MONITORING YEAR 1 ANNUAL REPORT

LONE HICKORY MITIGATION SITE

RE: Lone Hickory Mitigation Site – Monitoring Year 1 Report Final
Yadkin River Basin – CU# 03040101 – Yadkin County
DMS Project ID No. 97135
Contract # 006897

Wildlands Engineering, Inc. (Wildlands) has reviewed the Division of Mitigation Services (DMS) comments from the Draft Monitoring Year (MY) 1 report for the Lone Hickory Mitigation Site. Wildlands' responses to DMS' report comments are noted below in *italics*.

Wetland Re-establishment

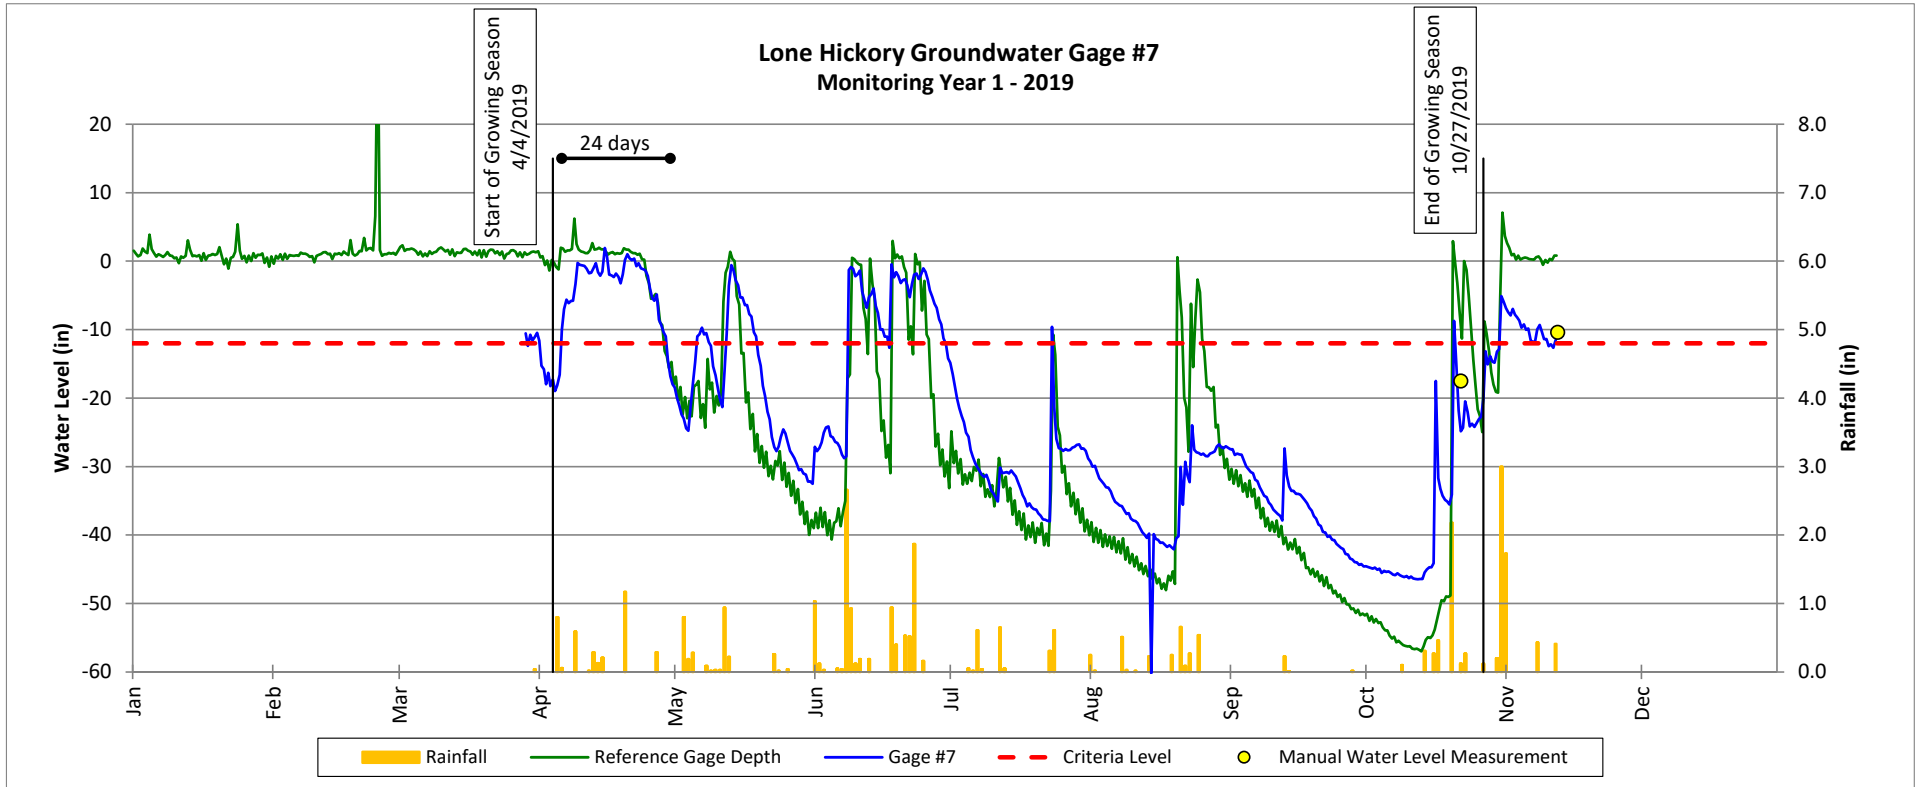
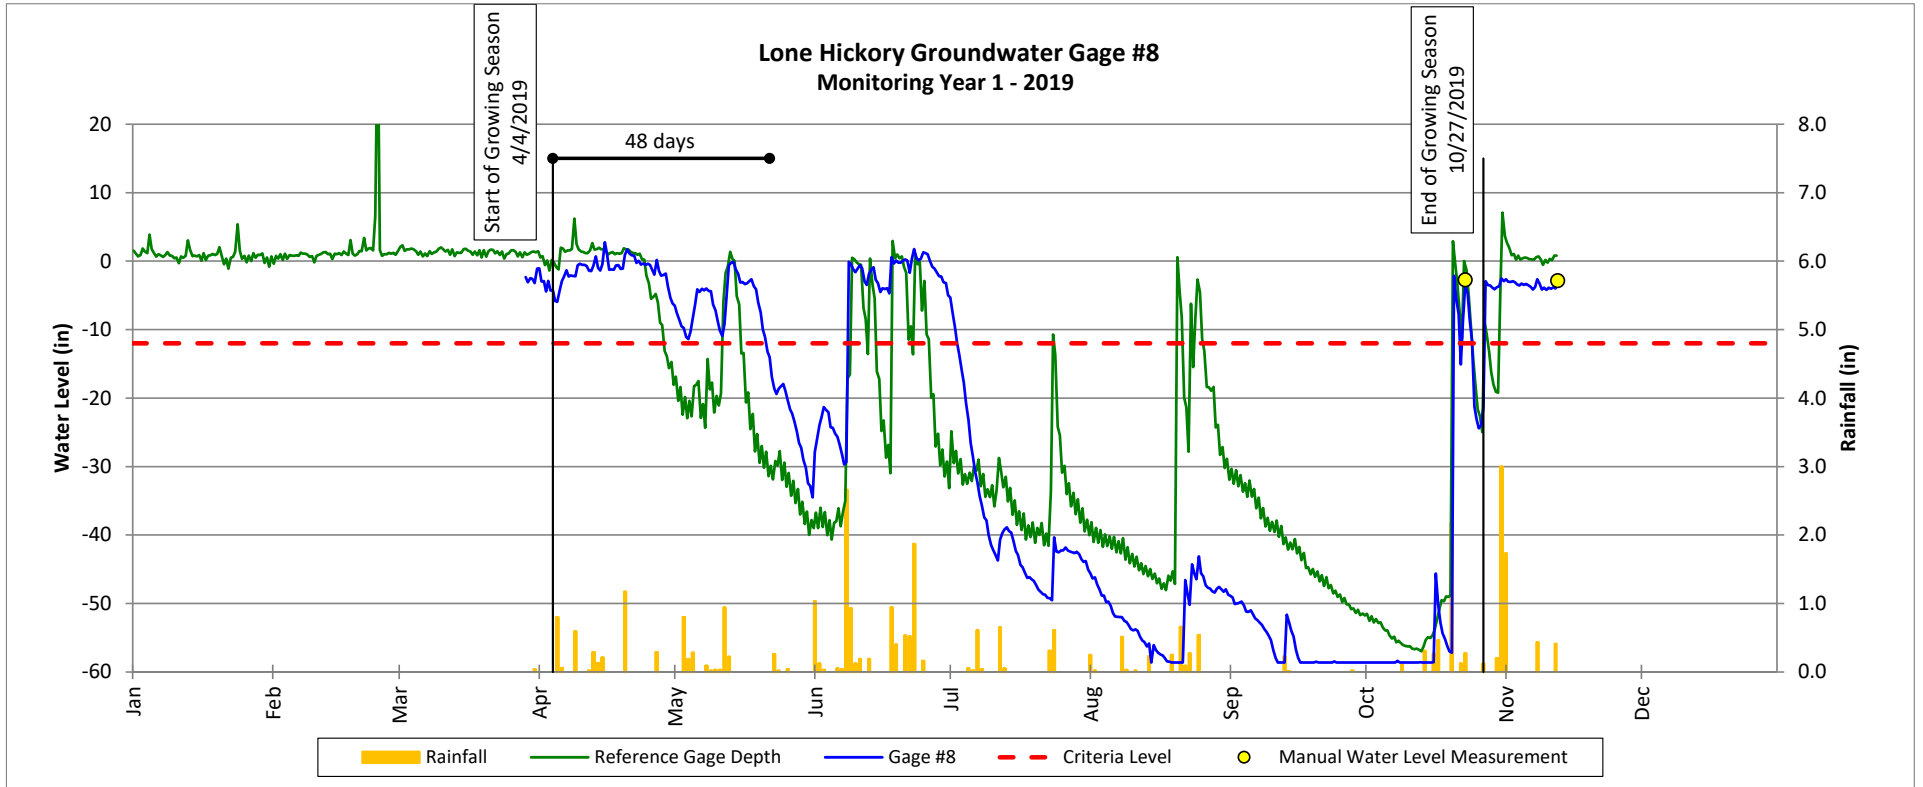
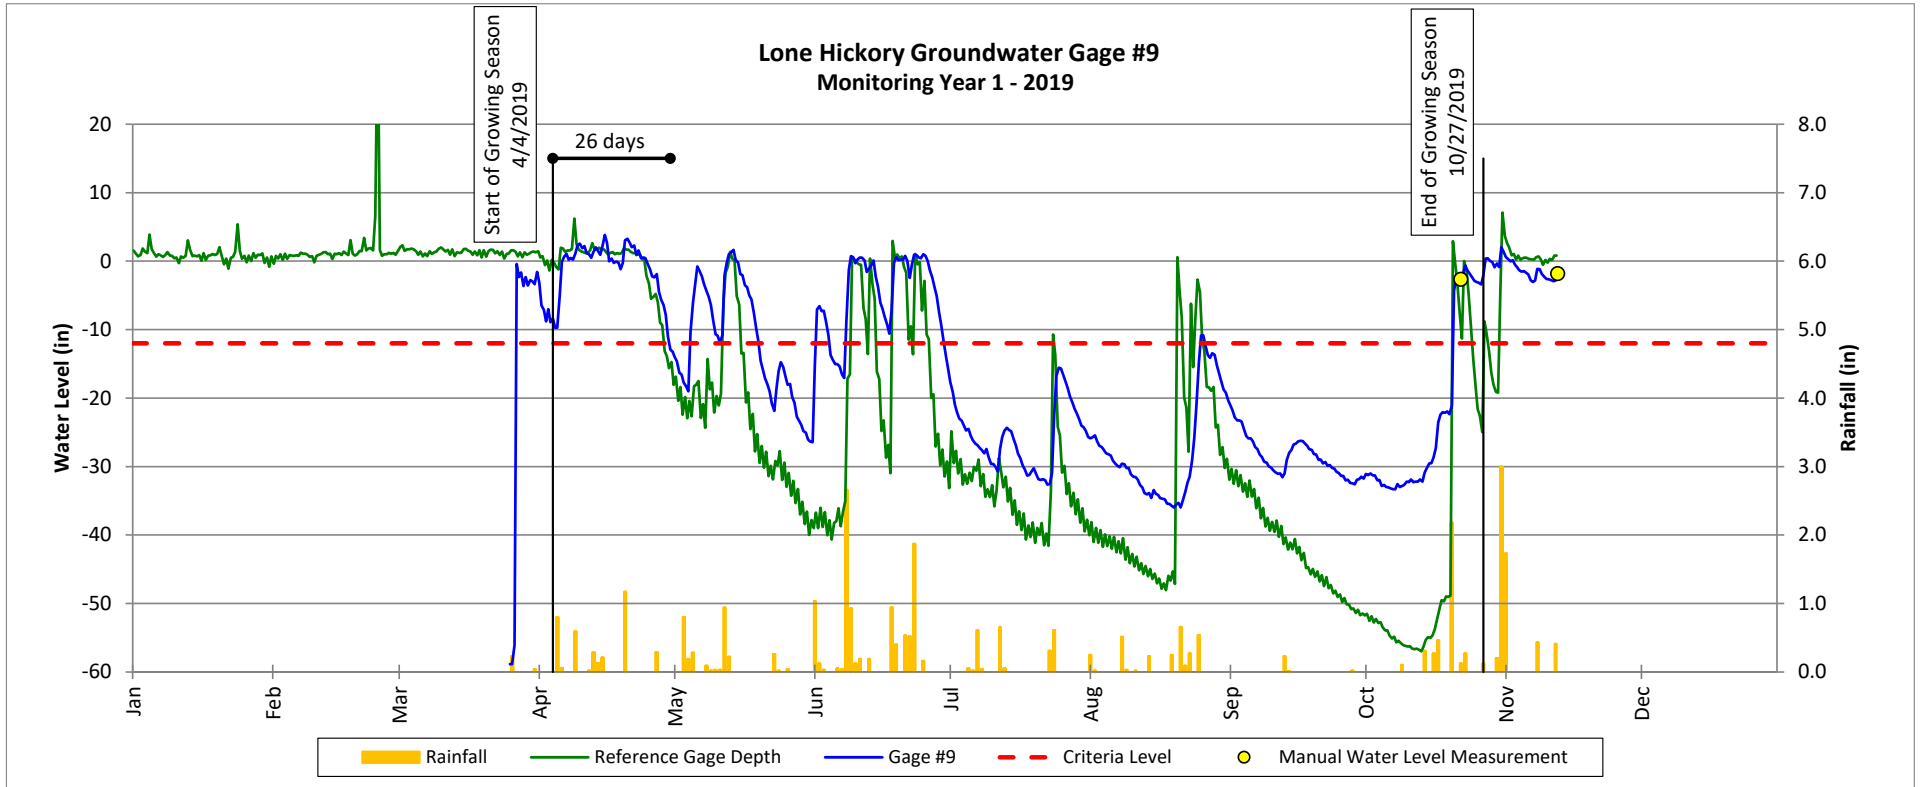
DMS comment; Groundwater gage plots: For clarity, consider adding the consecutive day number for each gage on the groundwater gage plots instead of using the currently shown 19-day bar. The 19-day bar adds some confusion to the plots without a description of what it corresponds too (9.2% of the growing season).

Wildlands response; For clarity, the maximum number of consecutive days achieved by each gage has been added to all groundwater gage plots instead of the 19-day bar.
